SUBDIVISION & ZONING
AMENDMENT STAFF REPORT**Date: January 20, 2011****APPLICANT NAME**

Peacock Subdivision

CONTEMPLATED USESubdivision approval to create a legal lot of record and
Zoning approval to rezone the site from R-1, Single-Family
Residential District, to B-1, Buffer Business District, to
allow commercial office space.**It should be noted, however, that any use permitted in
the proposed district would be allowed at this location if
the zoning is changed. Furthermore, the Planning
Commission may consider zoning classifications other
than that sought by the applicant for this property.****REASON FOR**
REZONINGChanges in conditions in a particular area make a change in
the Ordinance necessary and desirable.**TIME SCHEDULE**
FOR DEVELOPMENT

DETAIL SITE PLAN

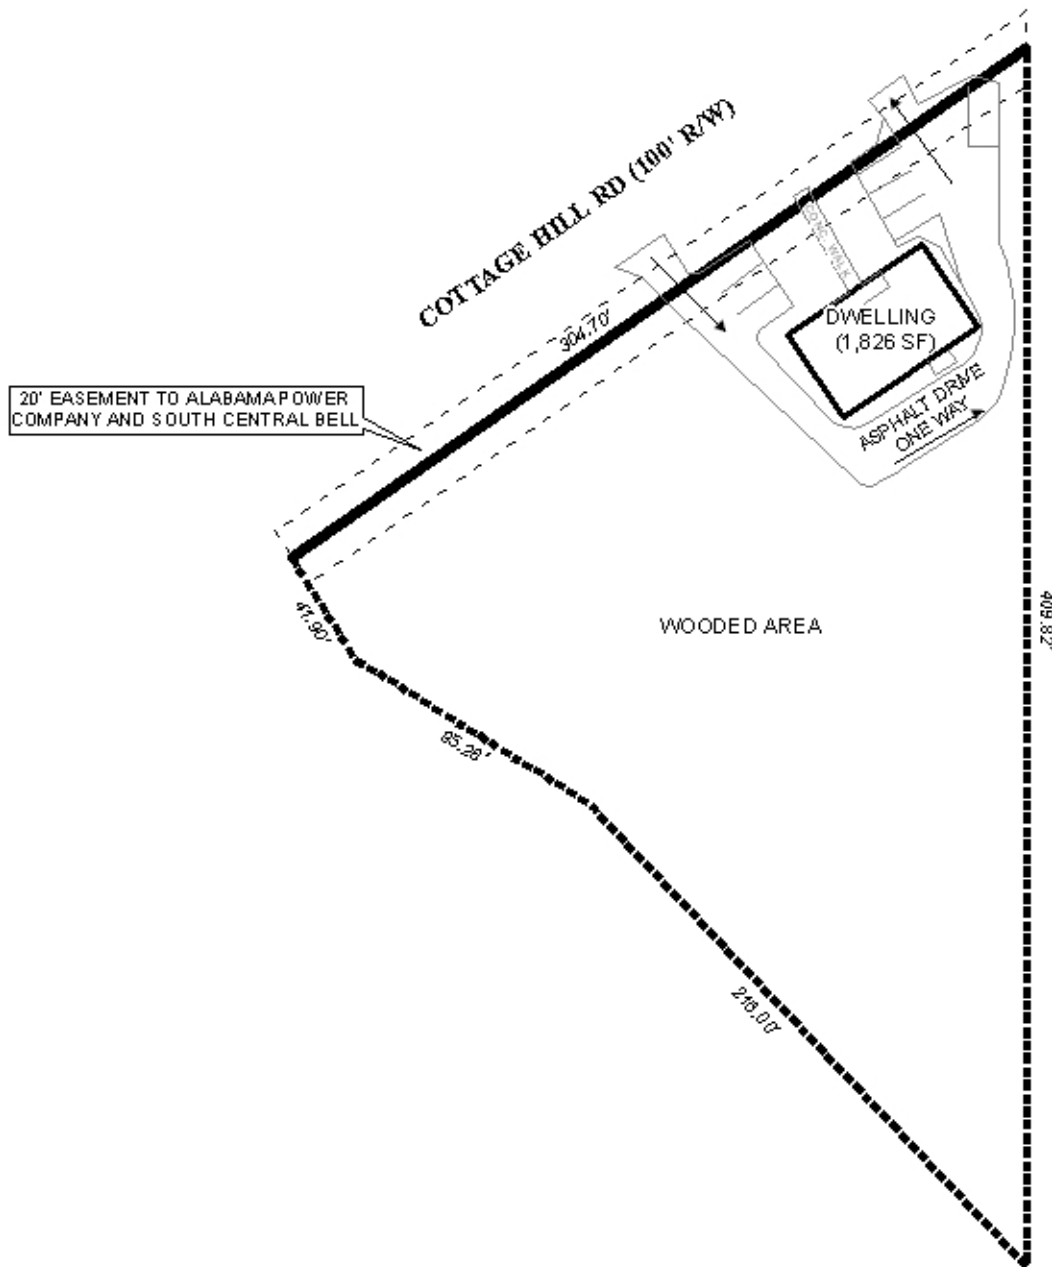
The site fronts onto Cottage Hill Road, a proposed major street according to the Major Street Plan Component of the Comprehensive Plan. The preliminary plat illustrates the current right-of-way along Cottage Hill Road as 100-feet. As a Major Street, Cottage Hill Road is required to provide a right-of-way of 100 feet, thus no dedication is required.

Currently, the site is accessed by two, one-way curb cuts from Cottage Hill Road. No change is illustrated on the site plan. However, if determined by Traffic Engineering that curbs cuts should be modified, the size, location, and design of all curb cuts to be approved by Traffic Engineering and conform to AASHTO standards.

The proposed lot size is indicated on the plat; therefore the lot size, in square feet, should be depicted on the Final Plat as well, or a table with same information provided.

- 1) placement of a note on the Final Plat limiting the development to the two existing curb cuts to Cottage Hill Road, if the site is redeveloped in the future the size, location, and design of all new curb cuts to be approved by Traffic Engineering and conform to AASHTO standards;

- 3) depiction 25-feet minimum building setback from the centerline of Cottage Hill Road on the Final Plat;
- 4) compliance with Engineering comments (*Show the limits of the flood plain on the plat. Also show the Minimum Finished Floor Elevation on each lot on Plat. There is to be no fill placed within the limits of the flood plain without providing compensation. Width of drainage easement subject to change upon completion of review by City Engineer. Must comply with all storm water and flood control ordinances. Any work performed in the right of way will require a right of way permit.*);

- 6) placement of the lot size labeling to depict the lot size in square feet on the Final Plat; and
- 7) full compliance with all municipal codes and ordinances.
